SHOWA REAR SHOCK ABSORBERS / XL-1000

HARLEY-DAVIDSON MOTOR CO., INC.

REAR SHOCK ABSORBER MOUNTING

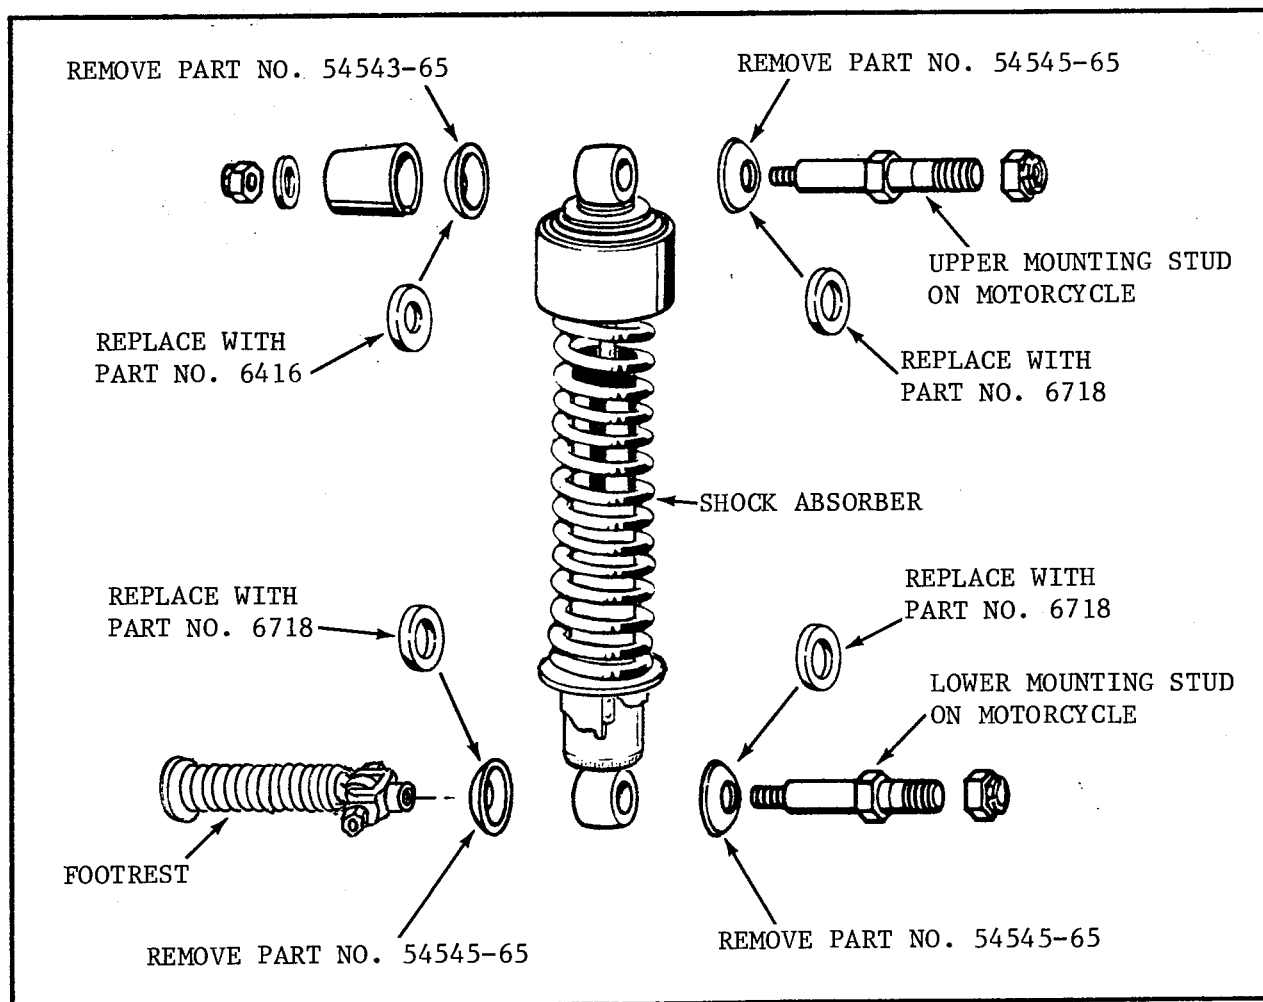
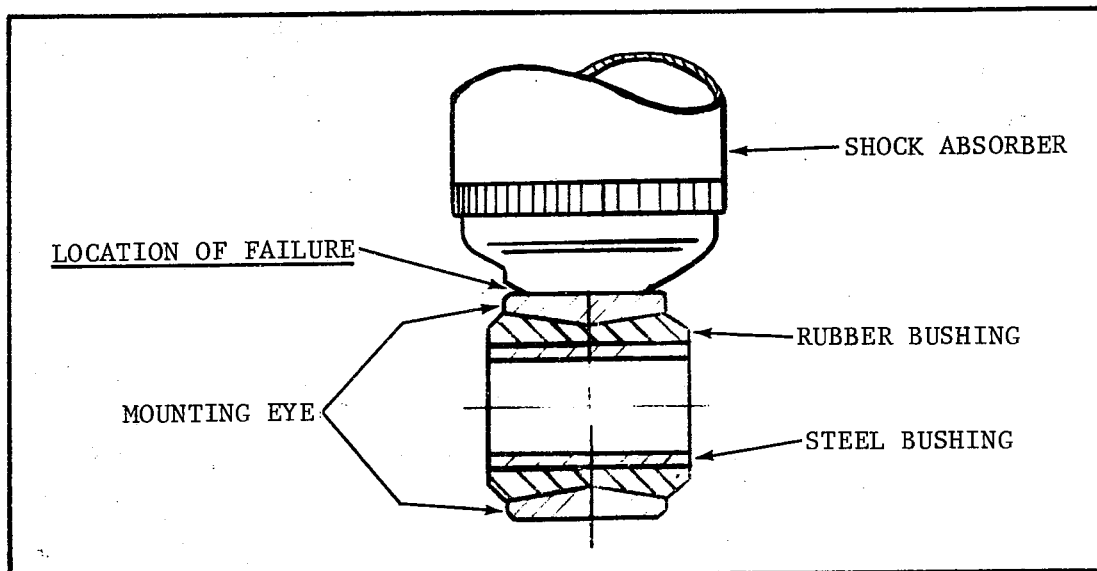
The shock absorbers of motorcycles involved in this safety defect are assembled with 3 cupped washers, part No. 54545-65 and 1 cupped washer, part No. 54543-65 instead of 3 flat washers, part No. 6718 and 1 flat washer part No. 6416.

Installation of incorrect cupped washers prevents either the upper or lower shock absorber eyes from pivoting freely when the suspension system moves, causing stress on the shock absorber eye leading to failure at low mileage. Failure of upper or lower mounting eye of both shock absorbers will cause the suspension to collapse and lock the wheel with possible loss of control of the vehicle, and an accident. Failure of the upper or lower mounting eye of only one shock absorber will not cause suspension collapse, but can affect handling detrimentally with possible loss of control and an accident.

Incorrect cupped washers are shown assembled and should not be used. Correct flat washers shown should be used instead of cupped washers.

We direct you to immediately contact the owners of these motorcycles and inform them that they must not be used until new shocks are installed with correct flat washers. This also applies to unsold motorcycles in your possession. If shock absorbers have not been assembled but are only in your parts stock, they must be used with correct flat washers part No. 6718 (3) and part No. 6416 (1) per shock absorber (See Illustration).

Do not reuse any shock absorbers which have been previously installed with cupped washers. Such shock absorbers could have incurred damage which is not apparent by visual inspection.
